FOR PUBLIC HEARING PETITION NO. 2006-48

Providence Road West Area Elementary
 Charlotte Mecklenburg Schools
 Charlotte, NC
 Petition Number 2006-48

Sheet Title:
 Schematic Site Plan

Technical Data Sheet

Sheet No:
RZ.1

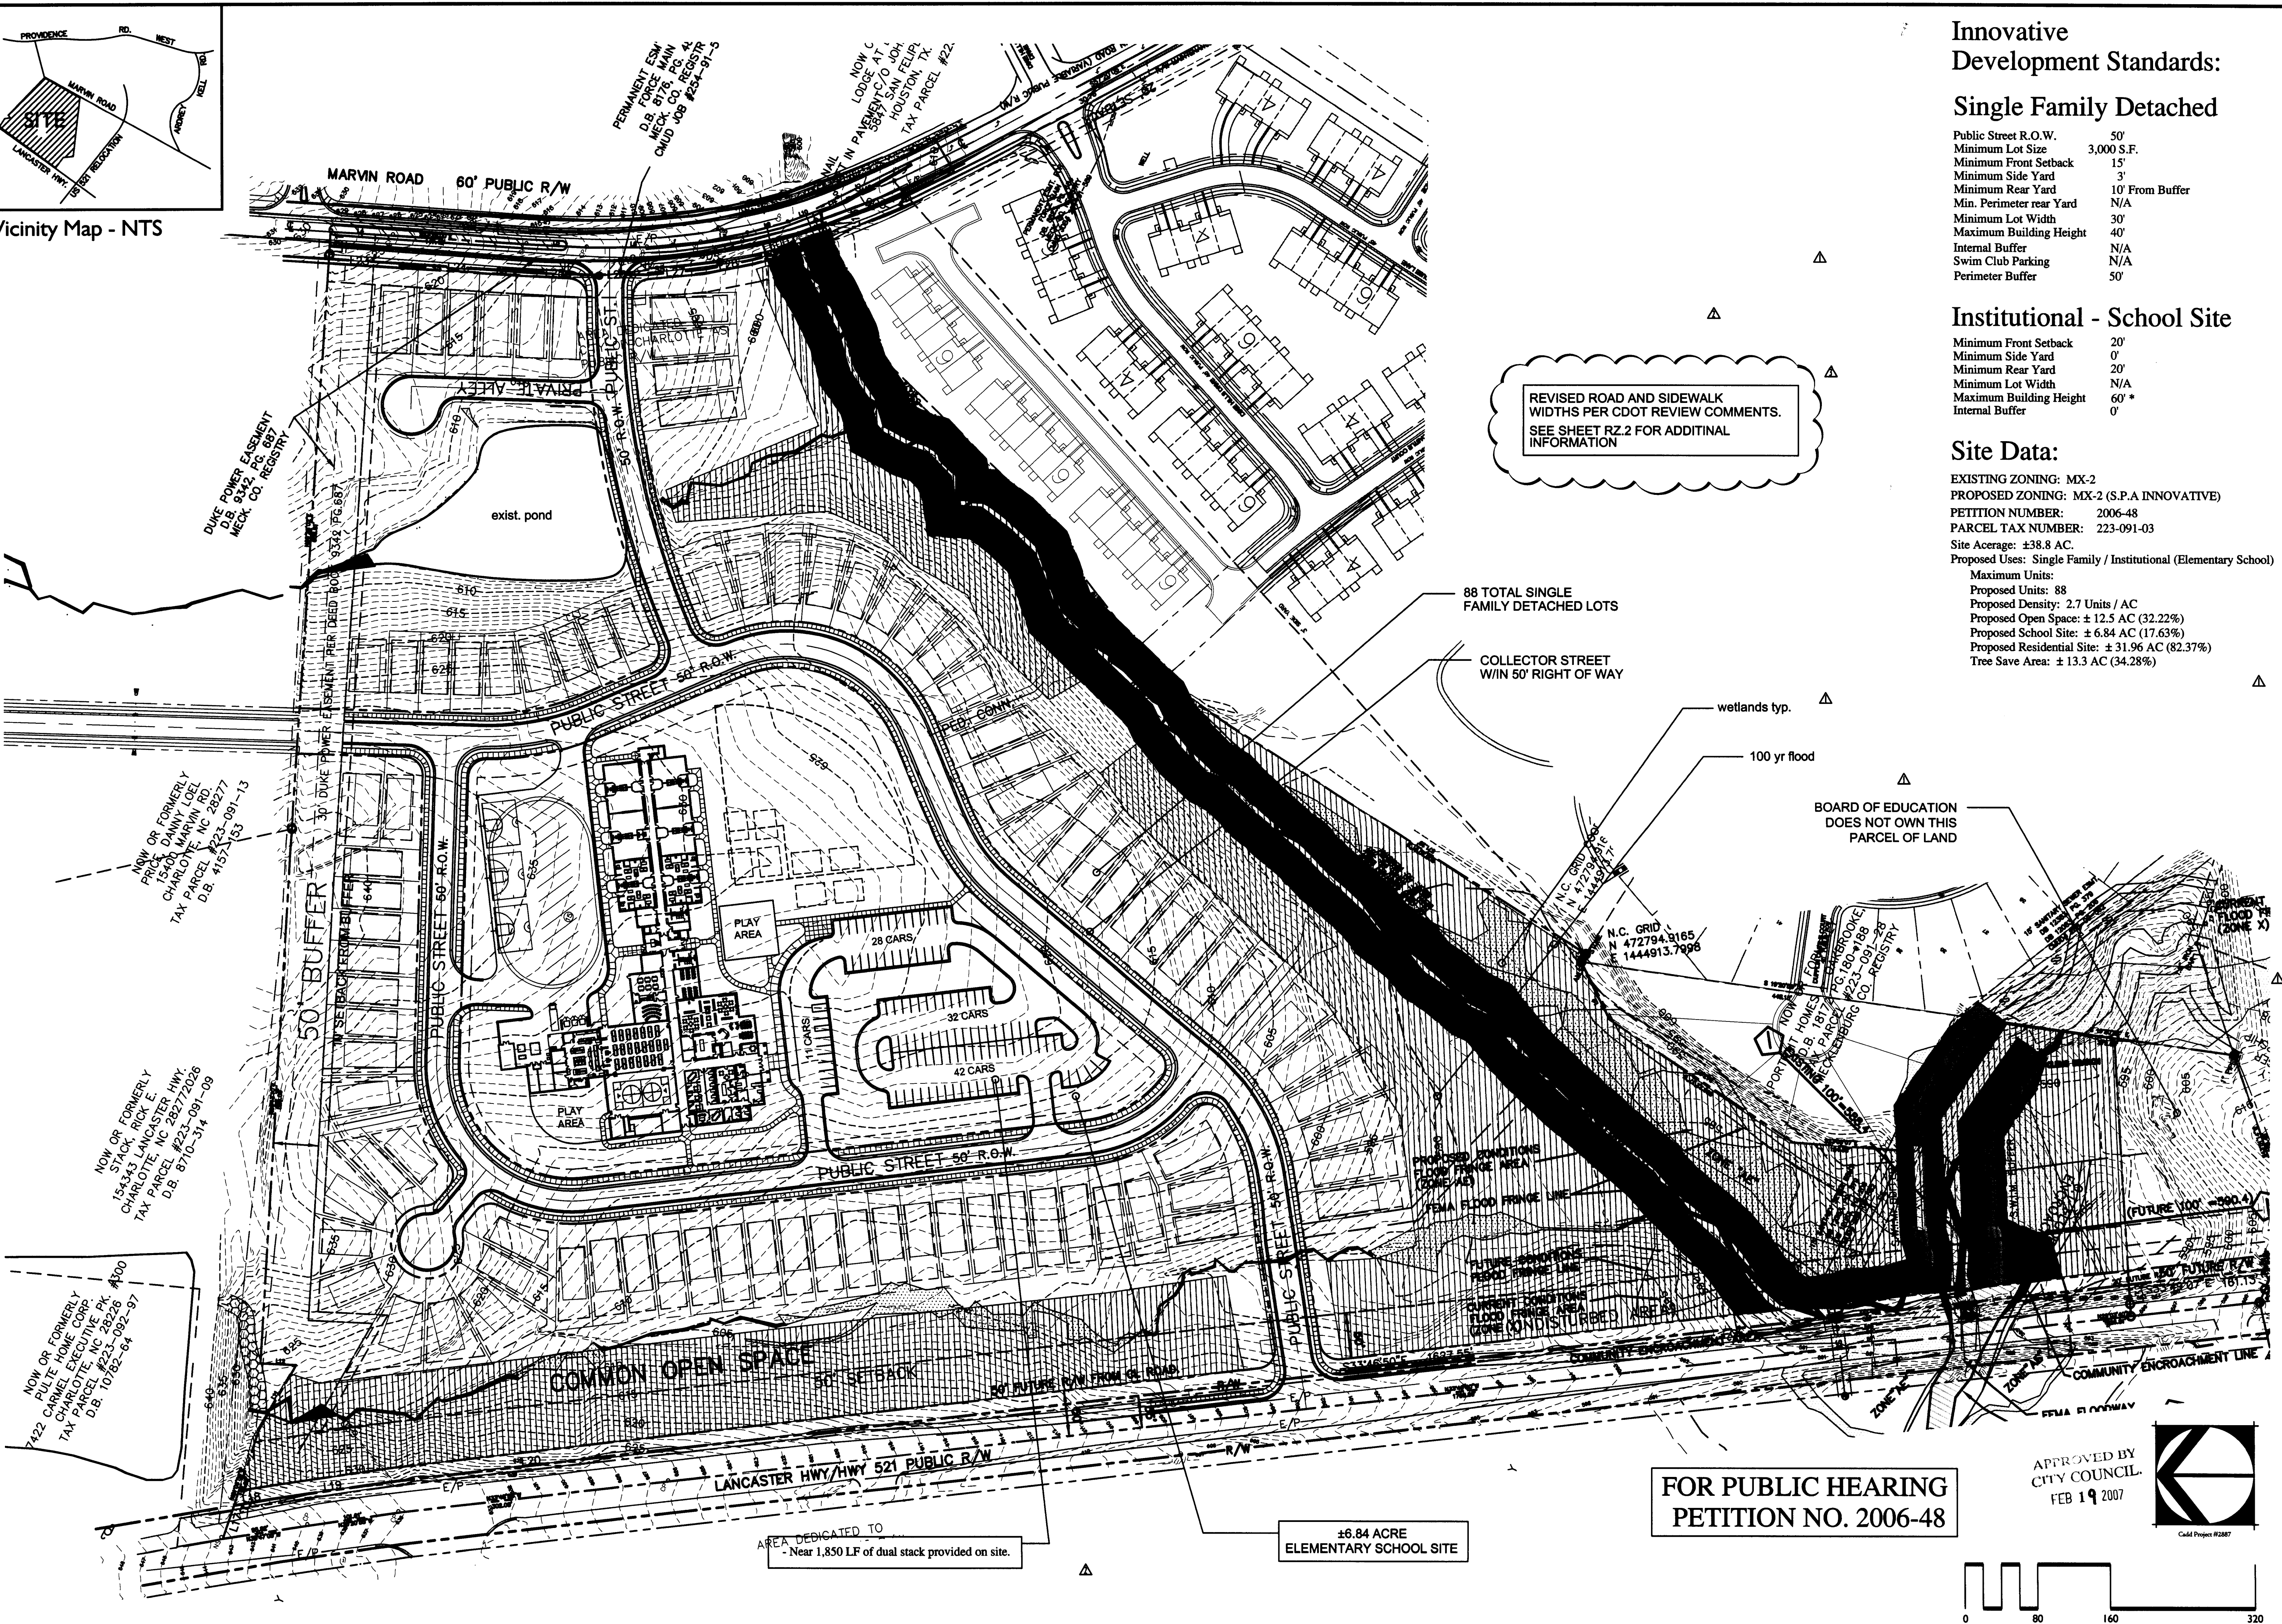
REVISED ROAD AND SIDEWALK WIDTHS PER CDOT REVIEW COMMENTS. SEE SHEET RZ.2 FOR ADDITIONAL INFORMATION

Vertical curb and gutter (2'-6") will be provided on the school side of the ring road. Valley curb (2'-0") will be permitted on the residential side of the ring road.

With respect to the internal road leading from Lancaster Hwy to Marvin Rd, the pavement section along the first 150 feet leading from Lancaster Hwy will be 30' wide. The pavement section along the remainder of the road will be 27' wide, with a parking lane included on the northern side of the road segment adjacent to the school site.

The northern side of the road leading from Lancaster Hwy to Marvin Rd shall be built with a minimum 6' sidewalk.
